**SUSITNA
HYDROELECTRIC PROJECT**

FEDERAL ENERGY REGULATORY COMMISSION
PROJECT No. 7114

**ALASKA POWER AUTHORITY
COMMENTS
ON THE
FEDERAL ENERGY REGULATORY COMMISSION
DRAFT ENVIRONMENTAL IMPACT STATEMENT
OF MAY 1984**

**VOLUME 2B
TECHNICAL COMMENTS
-AQUATIC RESOURCES**

FIGURE 1

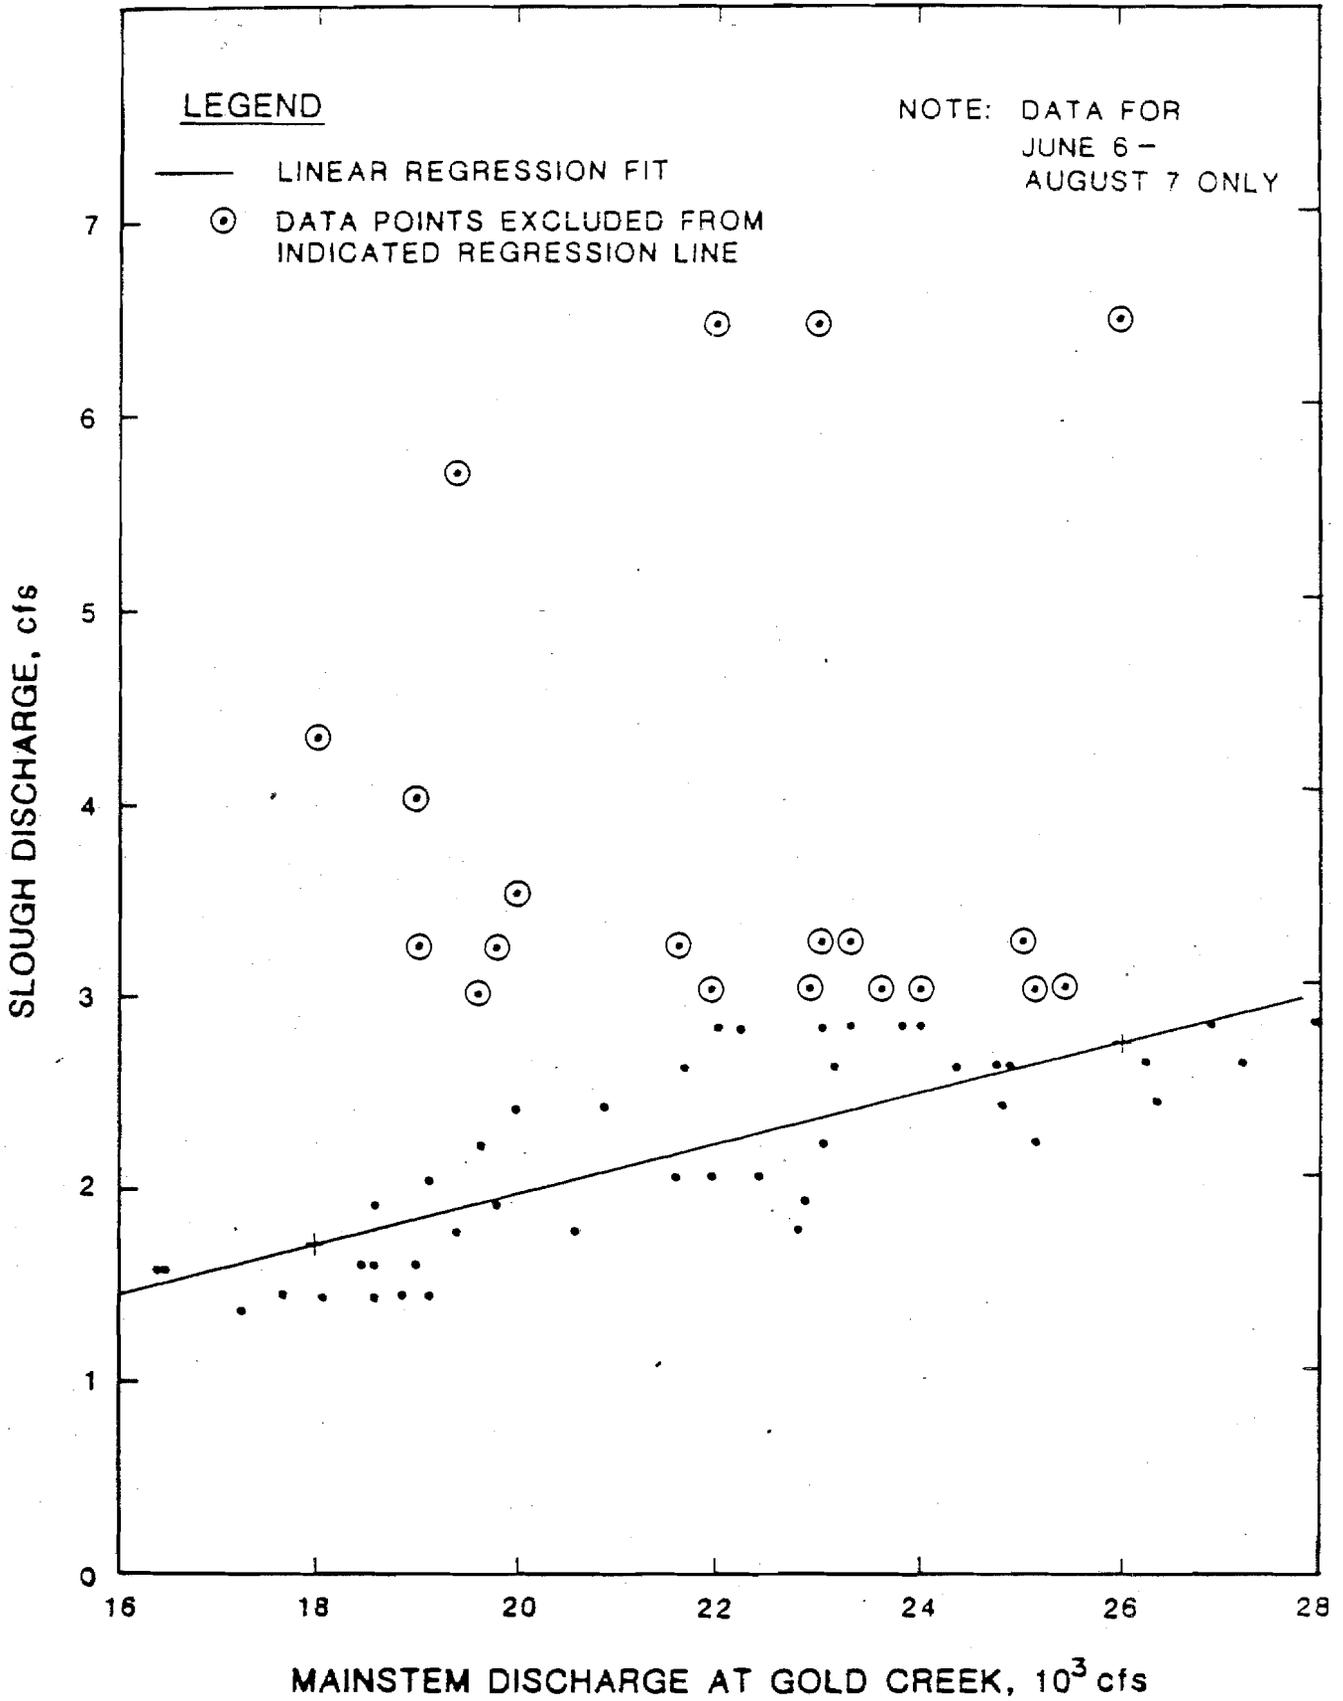
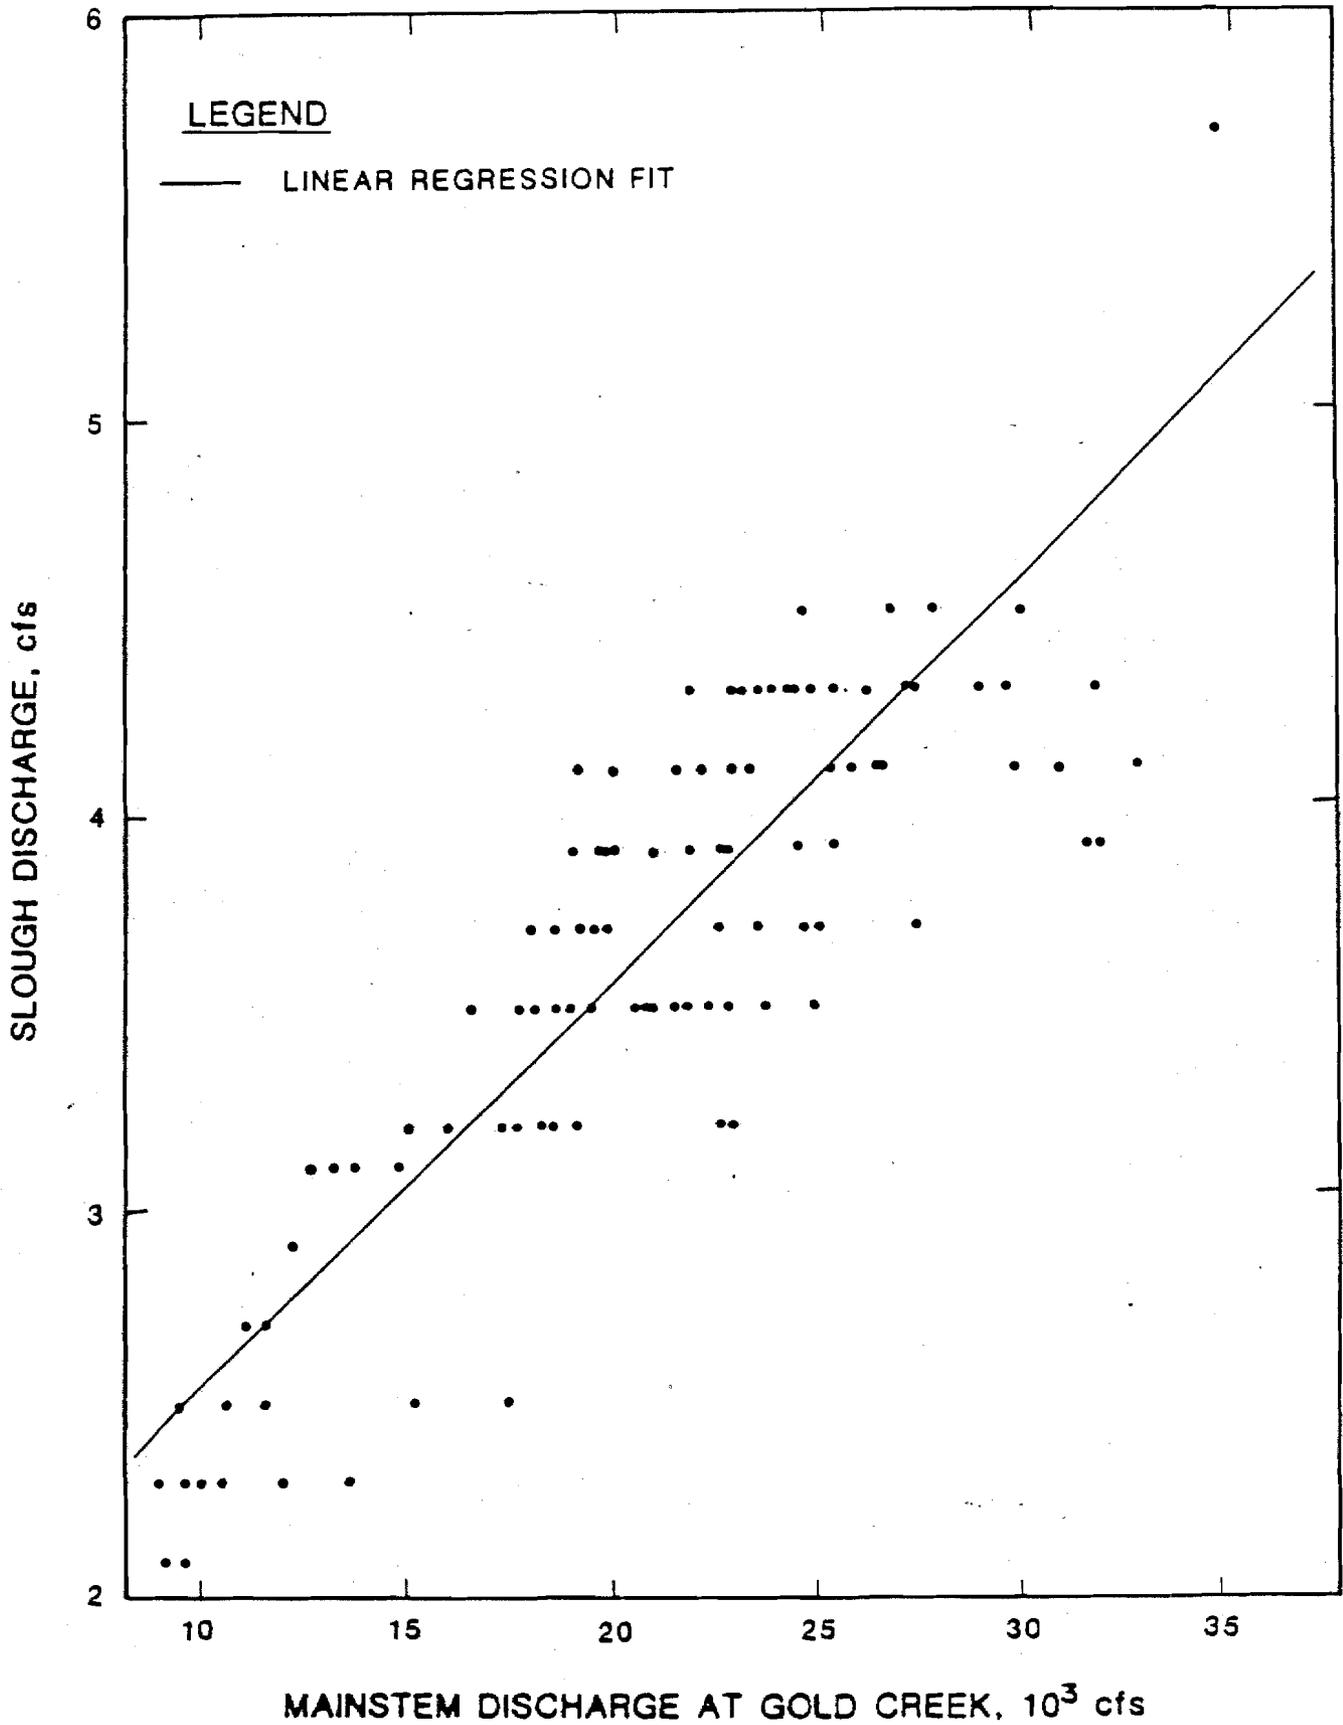
TECHNICAL COMMENT: It has been possible to isolate periods when overtopping of upstream berms by mainstem water levels and local runoff into the sloughs from tributaries and rainfall do not contribute significantly to slough flow (Appendix VII - Slough Geohydrology Studies). Using statistical analyses, inferences can be drawn of the relationships between mainstem discharge and the apparent groundwater upwelling in the sloughs for these periods. The derived relationships for Sloughs 8A, 9 and 11 are shown on the attached Figures 1 through 3, which are from Appendix VII of this document.

Slough 9 is subject to overtopping at discharges in excess of 16,000 cfs (ADF&G 1984c). Therefore, the relationship shown in Figure 2 is based solely on those points for which mainstem discharges were less than 16,000 cfs at Gold Creek. Two points were not considered in the analysis. It is possible these represent local runoff from storms.
